DATE: 12/7/23

SUBJECT: ADDENDUM NO. 2 TO THE BIDDING DOCUMENTS FOR

CDB-818-010-103  
REPAIR AND REPLACE ROOFS – PHASE 3  
WESTERN ILLINOIS UNIVERSITY  
ILLINOIS BOARD OF HIGHER EDUCATION  
MACOMB, MCDONOUGH COUNTY, ILLINOIS

ROOF PLANS - SIMPKINS HALL AND COFAC RECITAL HALL CONNECTOR  
 REPAIR AND REPLACE ROOFS - PHASE III  
 ILLINOIS BOARD OF HIGHER EDUCATION  
 WESTERN ILLINOIS UNIVERSITY  
 MACOMB, McDONOUGH COUNTY

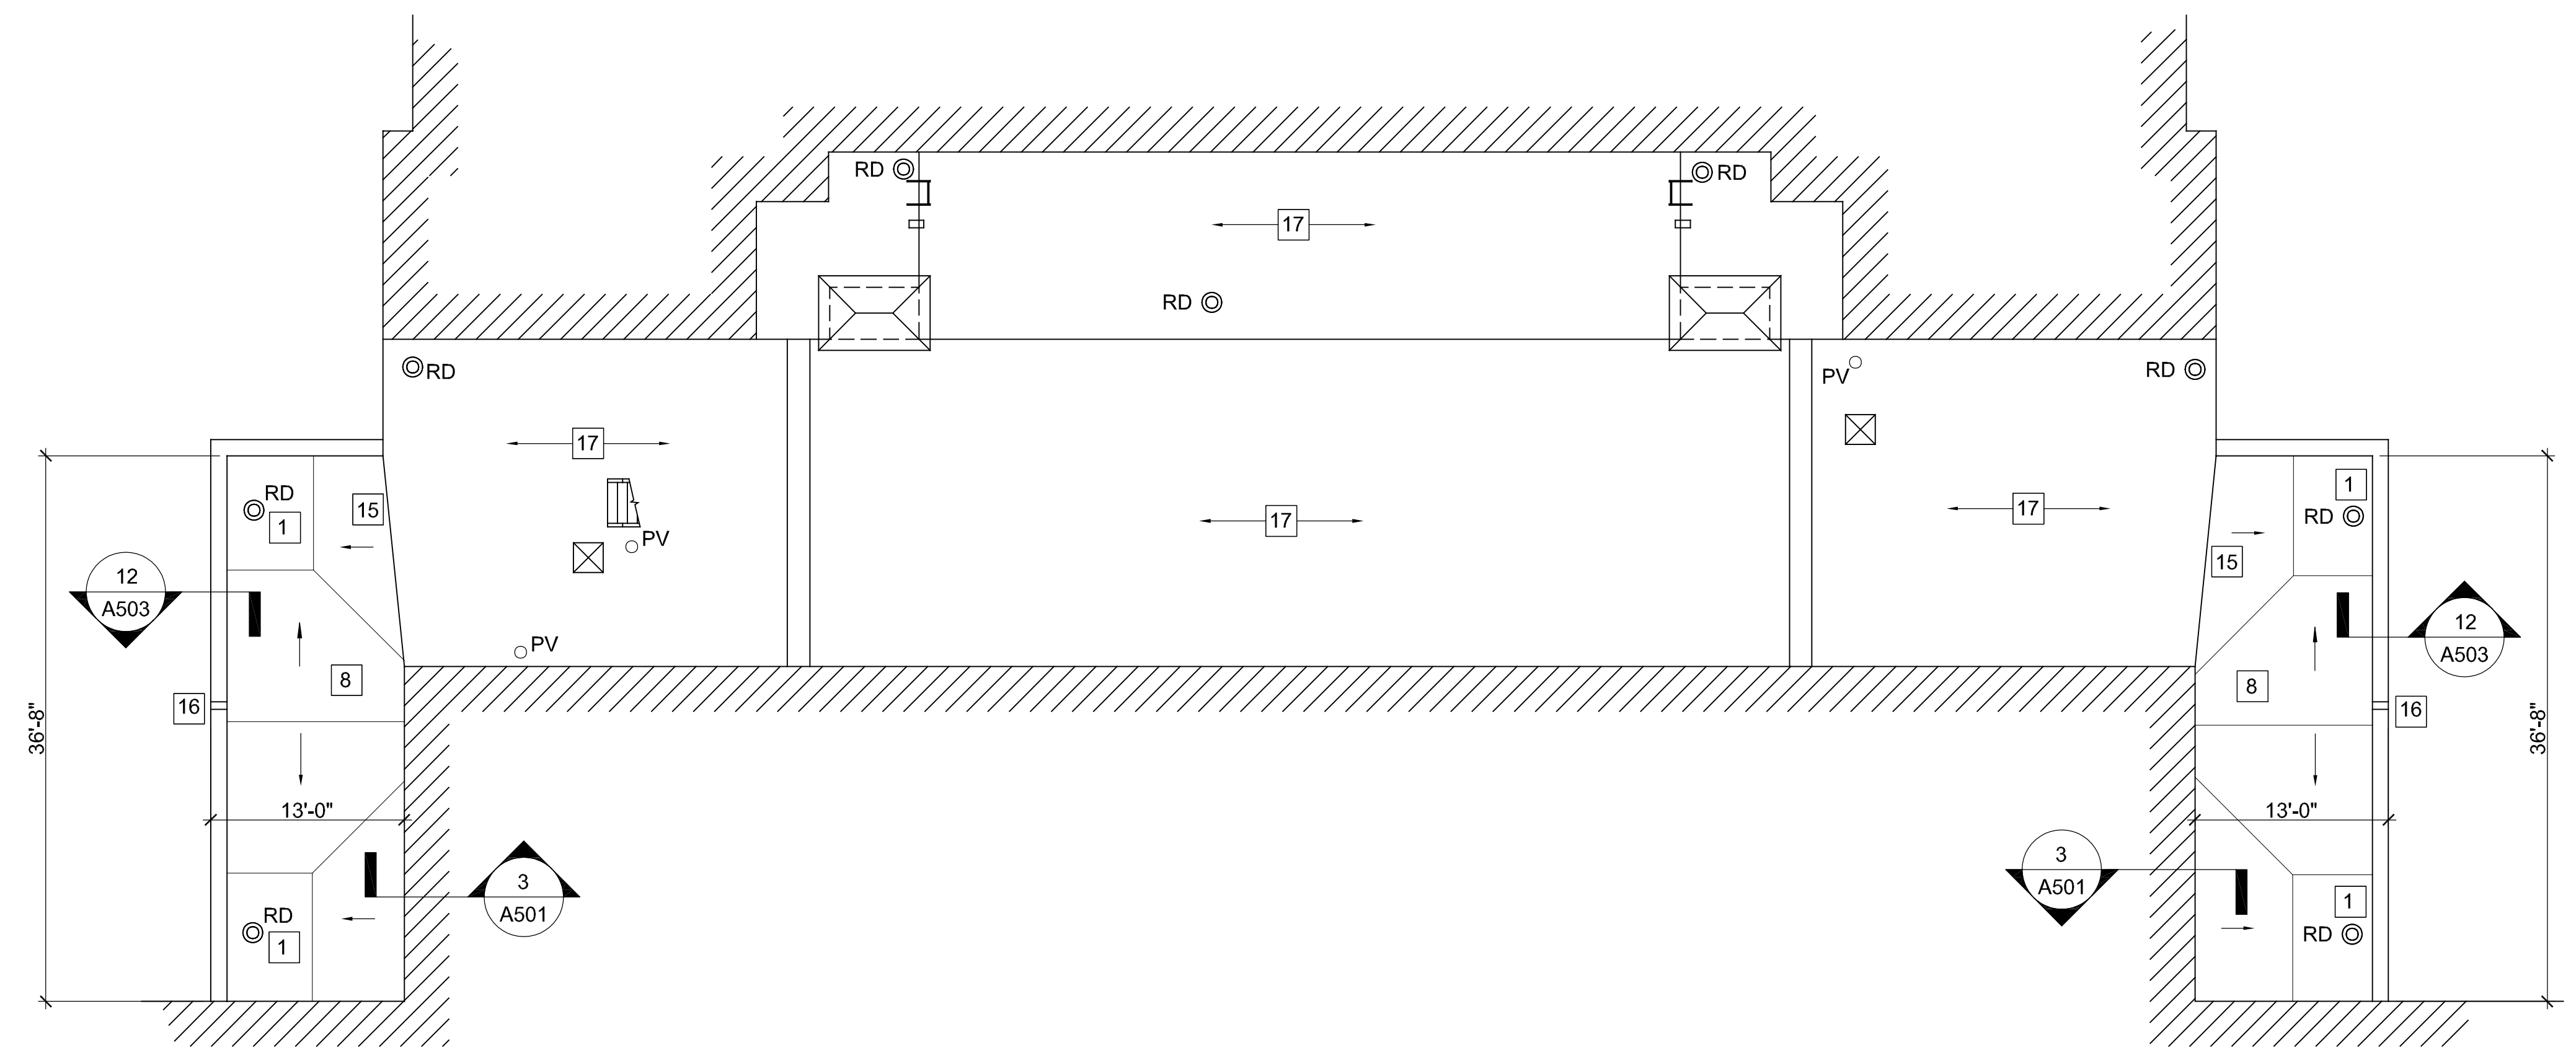
6. SHEET A102: Revisions are as follows:
  - a. Revise Keyed Note #8 to read, “Slope insulation at 1/4”/12” minimum (U.N.O.)”
  - b. Areas on plan around the skylights are noted to slope the insulation at 1/8”/12”.

- c. Added Keyed Note #18 addressing the existing decorative terra cotta at the east penthouse roof.
7. SHEET A102, A103: Clarify - The existing roof deck at Simpkins Hall is gypsum; the existing roof deck at COFAC Recital Hall and Connector is concrete.

- NEW EPDM MEMBRANE, RECOVERY BOARD, AND ROOF INSULATION ATOP EXISTING ROOF DECK. SEE DETAIL 1/A501 - SLOPE INSULATION AT 1/4":12" MINIMUM (U.N.O.)
  - NEW COLLECTION BOX AND DOWNSPOUT AT EXISTING SCUPPER OPENING. SEE DETAIL 6/A502

- REMOVE EXISTING DECORATIVE TERRA COTTA AND RETURN TO OWNER - INFILL EXISTING WALL WITH NEW INSULATION AS REQUIRED FOR WALL FLASHING
